**Project/File: DRH12-00033**

This is a conditional-use permit application for the construction of a 7 story mixed use apartment building. The site is located at 620 S. 9<sup>th</sup> Street in Boise, Idaho.

**Lead Agency:** City of Boise

# Site Plan

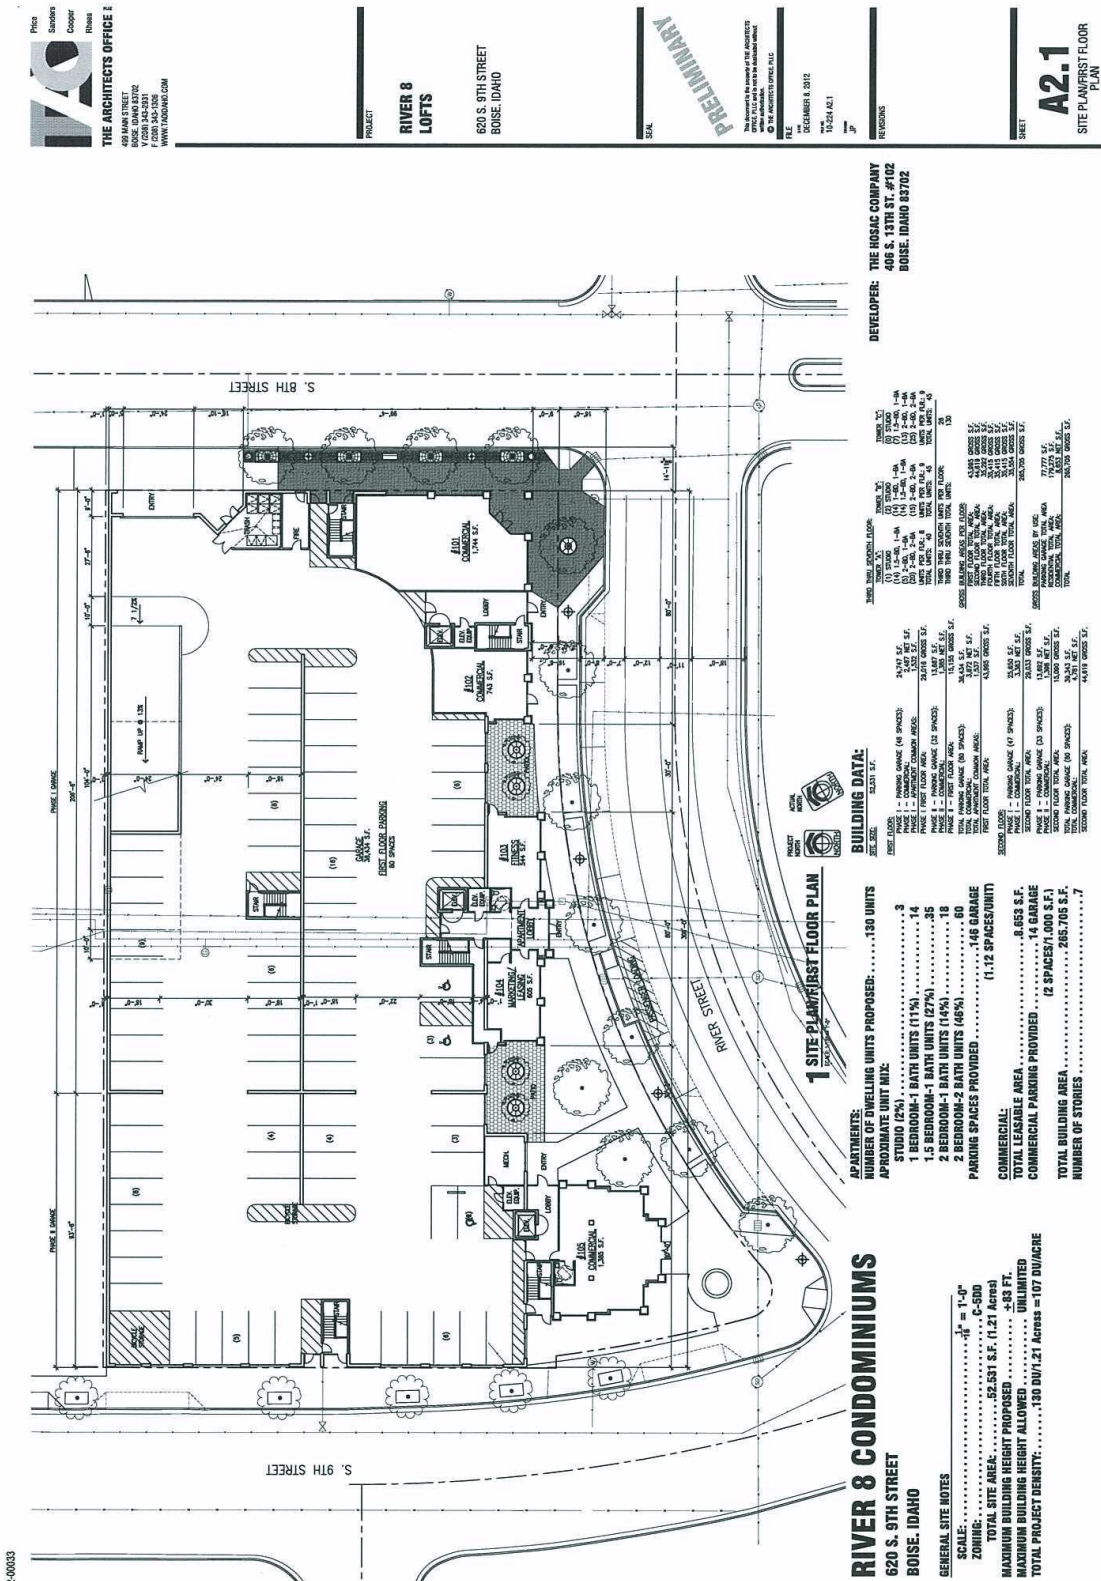
- c. **Applicant Proposal:** The applicant is proposing to construct 7-foot wide bike lane, 8-foot wide parking lane, vertical curb, gutter, 8-foot wide planter strip, and 8-foot wide sidewalk on River Street, abutting the site.
- d. **Staff Comments/Recommendations:** The applicant's proposal meets the intent of the MSM for a Towncenter Collector and should be approved, as proposed. The sidewalk is proposed to be constructed outside of the existing right-of-way; therefore, the applicant should be required to provide the District with an easement for any portion of sidewalk that is located outside of the right-of-way.

District Traffic Services staff reviewed the proposed on-street parking and had no issues with the proposal. The applicant should enter into a hold harmless agreement with the District

- c. **Applicant Proposal:** The applicant is proposing to construct vertical curb, gutter and a 15-foot wide paver sidewalk with tree wells, on 8<sup>th</sup> Street abutting the site.

- c. **Applicant's Proposal:** The applicant is proposing to close the 25-foot wide driveway located 80 feet west of the intersection of River Street and 8<sup>th</sup> Street with vertical curb, gutter and sidewalk.

To address the Fire Department's concerns regarding access to the site, the applicant is proposing to reduce the existing 50-foot wide driveway onto River Street to 30 feet in width and replace the unused portion of driveway with vertical curb, gutter, and sidewalk. The driveway would be for emergency access only and is proposed to be signed, as such.

The applicant's proposal to replace the existing 50-foot wide driveway with a 30-foot wide driveway does not meet District Driveway Location Policy; however, staff is recommending a modification of policy to allow the driveway as proposed. Staff's recommendation is due the fact that the driveway is a requirement of the Boise Fire Department (see attachment 3), and would be restricted and signed, as such. The applicant should be required to coordinate the construction of the driveway and a signage plan to restrict the driveway for emergency services only with District Traffic Services and Development Review staff.

1. Construct a 7-foot wide bike lane, 8-foot wide parking lane, vertical curb, gutter, 8-foot wide planter strip, and an 8-foot wide sidewalk on River Street abutting the site, as proposed. Provide ACHD with an easement for any segment of the sidewalk located outside of the right-of-way. Enter into a license agreement with the City of Boise regarding the sidewalk, planter strip and other streetscaping/landscaping proposed to be located within the right-of-way.

3. Construct vertical curb, gutter and a 15-foot wide paver sidewalk with tree wells on 8<sup>th</sup> Street abutting the site, as proposed. Enter into a license agreement with the City of Boise regarding the sidewalk, tree wells and other streetscaping/landscaping proposed to be located within the right-of-way.

6. Reduce the 50-foot wide driveway on River Street located 140 feet east of the intersection of River Street and 9<sup>th</sup> Street to be 30 feet wide, as proposed. Replace the unused portion of driveway with vertical curb, gutter, and sidewalk to match the existing improvements on either side. This driveway is to be restricted for fire department use only. Coordinate the design and signage program with District Traffic Services and Development Review staff for the driveway restriction.

7. Replace the 25-foot wide driveway on River Street located 80 feet west of the intersection of River Street and 8<sup>th</sup> Street with vertical curb, gutter, and sidewalk to match the existing improvements on either side, as proposed.

8. Widen the 30-foot wide driveway on 8<sup>th</sup> Street located 170 feet north of the intersection of 8<sup>th</sup> Street and River Street by 10 feet so as to be a total of 40 feet wide. Pave the driveway its full-width at least 30-feet into the site beyond the edge of pavement.
